Work Order ID 136952

Item Name: Bearing Assembly

DESIGN <i>#</i>	DRAWN BY <i>CP</i>	DART AEROSPACE LTD HAWKESBURY, ONTARIO, CANADA	
CHECKED <i>#</i>	APPROVED <i>#</i>	DRAWING NO. D3183	REV. C SHEET 1 OF 4
DATE 04.02.17	TITLE BRACKET ASSEMBLY	SCALE 1:1	
A	03.01.24	NEW ISSUE	
B	03.06.17	REMOVE BEARING; 1.012 WS 0.882	
C	04.02.17	ADD -045/-9; 0.182 WAS 0.431	
C1	# 04.11.09	0.830 WAS 0.850

DRAWING NO. D3183	TITLE BRACKET ASSEMBLY	REV/C1	DART AEROSPACE LTD ENGINEERING ORDER		D.E.O. NO. D3183-C1-1	SHEET NO. SHEET 1 OF 1	SCALE NTS
DRAWN <i>qp</i>	CHECKED <i>h</i>	MFG. APPR. <i>M</i>	APPROVED <i>MP</i>	DE APPR. <i>h</i>	DATE	DATE	DATE
DATE 10.05.14	DATE 10.06.30	DATE 10.06.30	DATE 10/06/30	DATE 10/06/30	DATE 10/06/30	DATE 10/06/30	DATE 10/06/30

D3183-5 BEARING:
SPECIFICATION CONTROL DRAWING

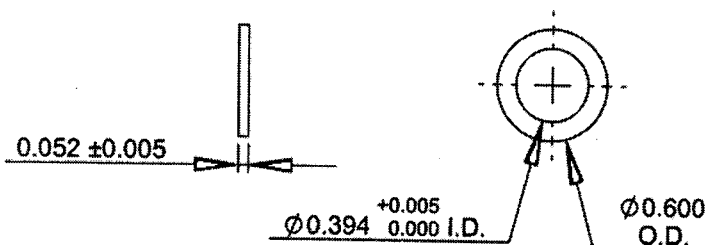
ADD POSSIBLE SUPPLIER: KML P/N 6800-ZZ

BASIC LOAD RATING REQUIREMENT: Cr = 1720 N (386 lb) MIN [DYNAMIC]
Cor = 840 N (188 lb) MIN [STATIC]
